# Access Compliance Report

## Public Rights-of-Way

### (Curb Ramps)

Intersection ID: 53401	Main Street: VAWTER_DR	Cross Street: AGNEW_DR	Location: SW
ADA ID: 736A31A45183	Ramp Type: Perp	Initial Pass/Fail: Fail	Overall Compliance: No
Severity Score: 8.75			
Codes/Mitigation Info/Possible Solution		Field Measurements/Component Compliance

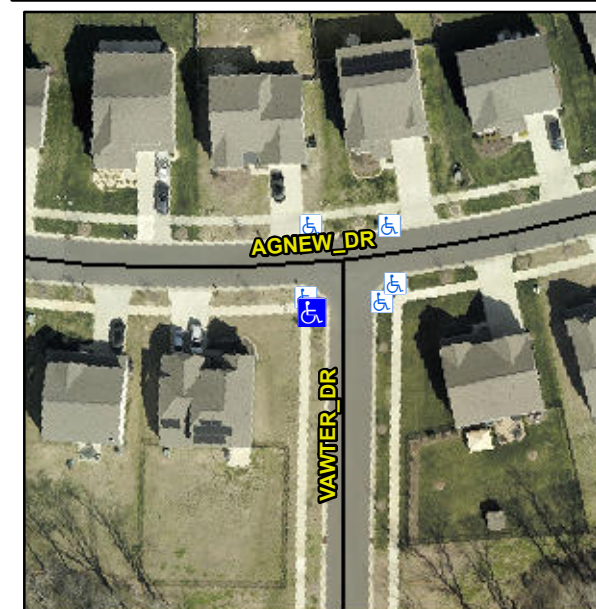
**Not Found, R304.5.1**

Compliance	Description	Data	Compliance	Description	Data
N/A	Ramp Length (in)	101.0	Yes	Ramp Slope (%)	5.3
No	Ramp Width (in)	46.5	Yes	Ramp XSlope (%)	0.4
N/A	Flare Type LT	N/A	N/A	Flare Type RT	N/A
N/A	Flare Slope LT (%)	N/A	N/A	Flare Slope RT (%)	N/A
N/A	Flare Traversable LT?	N/A	N/A	Flare Traversable RT?	N/A
N/A	Landing Length (in)	N/A	N/A	DWS Provided?	N/A
N/A	Landing Width (in)	N/A	N/A	DWS Contrast?	N/A
N/A	Landing Slope (%)	N/A	N/A	DWS Length (in)	N/A
N/A	Landing X Slope (%)	N/A	N/A	DWS Full Width?	N/A
N/A	Landing Curb? (Y/N)	N/A	N/A	DWS Offset (in)	N/A
N/A	Shared Landing?	N/A			
N/A	Gutter Ponding?	N/A	N/A	Gutter Slope (%)	N/A
N/A	Gutter Lip Ht (in)	N/A	N/A	Gutter X Slope (%)	N/A
N/A	Painted X Walk1?	No	N/A	Painted X Walk2?	N/A
	X Walk 1 Direction	To E		X Walk 2 Direction	N/A
N/A	X Walk 1 Width (in)	N/A	N/A	X Walk 2 Width (in)	N/A
	X Walk 1 Slope (%)	3.0		X Walk 2 Slope (%)	N/A
	X Walk 1 X Slope (%)	0.7		X Walk 2 X Slope (%)	N/A

**Remove & Replace Entire Ramp.**
